MEETING DATE: NOVEMBER 18, 2020

TO: PINAL COUNTY BOARD OF SUPERVISORS

CASE NO.: CSR-005-20 (Ocotillo Trails Marketplace) Amendment of CSR-001-07

### **Executive Summary:**

# PINAL COUNTY DEVELOPMENT SERVICES Comprehensive Sign Review Meeting April 7, 2007

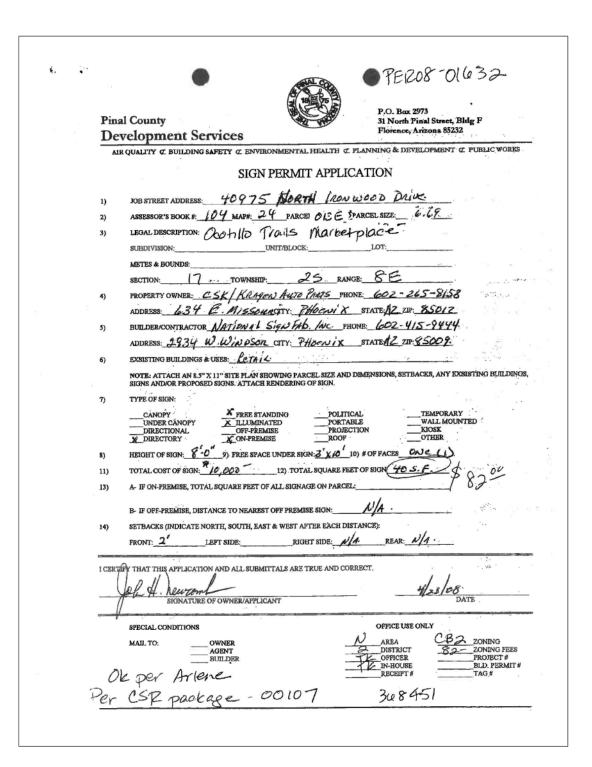
Monument Signs 1, 2, A, & B in revised plan is acceptable if moved as suggested in redlined plans. Monument signs A & B must be 12 feet max in height according to Sec 2213 of Comprehensive Sign Ordinance. Applicants must move corner sign #2 in revised plan back to position in original plan, but situate off of Ocotillo and move sign B to opposite side of drive entrance to ensure adequate distance from sign #2. (See site plan redlines)

Public Works needs sight visibility triangle (SVT) and right-of-way (ROW) info, "Locate signs entirely outside visibility triangle easement & ROW and use future ROW dimensions with a 33 foot sight visibility triangle.

Applicant requested a sign for each pad, request is denied by committee due to excessive signage. Applicant also requested to move sign #2 to corner to be considered neutral. Committee determined that corner is not considered neutral and would block visibility for motorists.

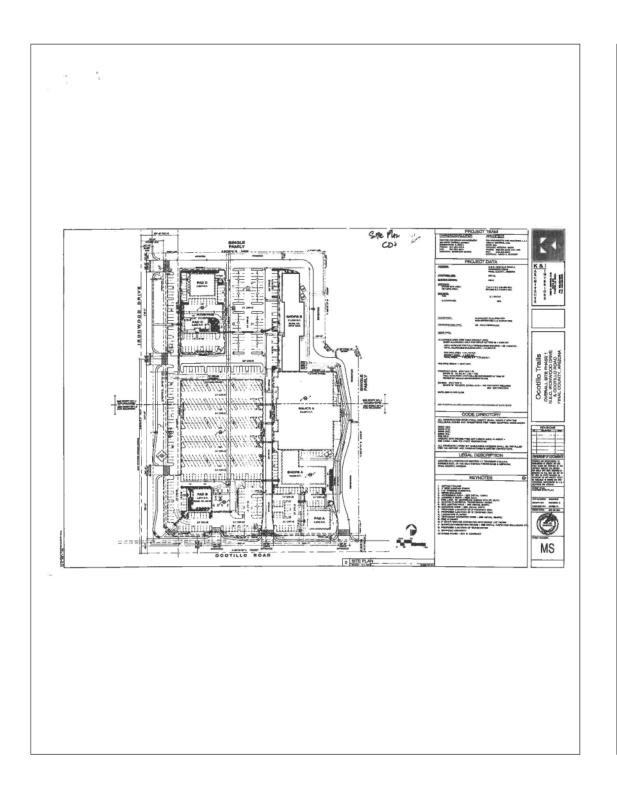
The monument signs need to be reduced from 15' in height to 12'  Monument signs #2 and #4 need to be removed; There are too many signs on the street frontage  Provide clarification on the center. Is the sign submittal for the entire center or a portion of the center?  Please provide the original size engineers or architectural drawing to determined site visibility for all monument signs.  Personal Removemble Naturial - signs. Com  Removemble Naturial - signs. Com  Removemble Naturial - signs. Com  Provide Carlotte Additional - signs and the signs and the signs and the signs are signs and the signs and the signs are signs and the signs and the signs are signs are signs are signs are signs and the signs are sig	-		
2 Monument signs #2 and #4 need to be removed; There are too many signs on the street frontage 3 Provide clarification on the center. Is the sign submittal for the entire center or a portion of the center? 4 Please provide the original size engineers or architectural drawing to determined site visibility for all monument signs.  Description of the center of a portion of the center?  Please provide the original size engineers or architectural drawing to determined site visibility for all monument signs.  Please provide the original size engineers or architectural drawing to determined site visibility for all monument signs.  Please provide the original size engineers or architectural drawing to determined site visibility for all monument signs.  Please provide the original size engineers or architectural drawing to determined site visibility for all monument signs.  Please provide the original size engineers or architectural drawing to determined site visibility for all monument signs.  Please provide the original size engineers or architectural drawing to determined site visibility for all monument signs.  Please provide the original size engineers or architectural drawing to determined site visibility for all monument signs.  Please provide the original size engineers or architectural drawing to determined site visibility for all monument signs.	Page #	Comment #	Please respond to all comments

- 1. This plan is for the entire project and not for just one phase.
- 2. Owner would like to keep the height at 15' for the main I.D. monument but if that is not possible find attached revised drawing at 12' height.
- 3. Owner requires a PAD sign for each PAD site. If we move PAD sign #3 to the po corner from its present location would that mitigate the closeness of signs?

The corner is treated as neutral to the location of the other signs by several cities. such as Chandler and Phoenix.
- 4. If sign #2 and #4 are to be deleted find revised sign plan attached.
